# Access Compliance Report

## Public Rights-of-Way

Intersection ID: 12018	Main Street: S_GRAHAM_ST	Cross Street: W_3RD-4TH_CONNECTOR_ST	Location: W
ADA ID: 243E39449C5C	Ramp Type: PerpDiag	Initial Pass/Fail: Fail	Overall Compliance: No
Severity Score: 8.75			
Codes/Mitigation Info/Possible Solution		Field Measurements/Component Compliance

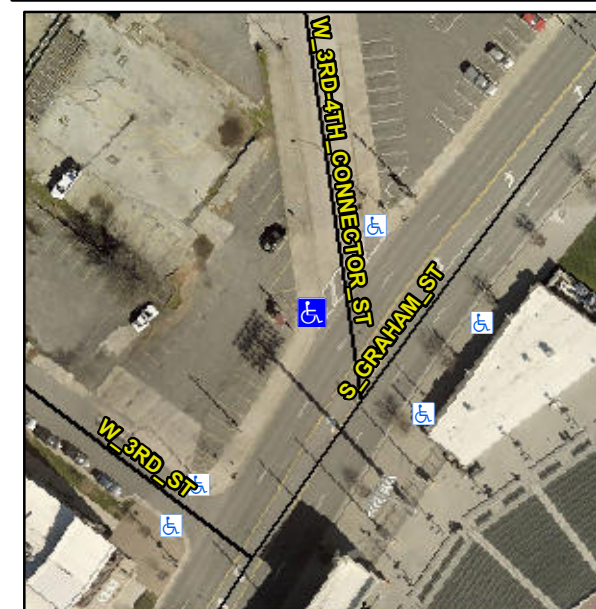
**Not Found, R304.5.1**

Compliance	Description	Data	Compliance	Description	Data
N/A	Ramp Length (in)	108.0	Yes	Ramp Slope (%)	6.3
No	Ramp Width (in)	42.0	Yes	Ramp XSlope (%)	0.4
N/A	Flare Type LT	N/A	N/A	Flare Type RT	N/A
N/A	Flare Slope LT (%)	N/A	N/A	Flare Slope RT (%)	N/A
N/A	Flare Traversable LT?	N/A	N/A	Flare Traversable RT?	N/A
N/A	Landing Length (in)	N/A	N/A	DWS Provided?	N/A
N/A	Landing Width (in)	N/A	N/A	DWS Contrast?	N/A
N/A	Landing Slope (%)	N/A	N/A	DWS Length (in)	N/A
N/A	Landing X Slope (%)	N/A	N/A	DWS Full Width?	N/A
N/A	Landing Curb? (Y/N)	N/A	N/A	DWS Offset (in)	N/A
N/A	Shared Landing?	N/A			
N/A	Gutter Ponding?	N/A	N/A	Gutter Slope (%)	N/A
N/A	Gutter Lip Ht (in)	N/A	N/A	Gutter X Slope (%)	N/A
N/A	Painted X Walk1?	No	N/A	Painted X Walk2?	Yes
	X Walk 1 Direction	To SE		X Walk 2 Direction	To NE
N/A	X Walk 1 Width (in)	N/A	N/A	X Walk 2 Width (in)	105.0
	X Walk 1 Slope (%)	0.2		X Walk 2 Slope (%)	2.2
	X Walk 1 X Slope (%)	1.6		X Walk 2 X Slope (%)	1.7

**Remove & Replace Curb Ramp With Two New Directional Ramps or Equivalent.**
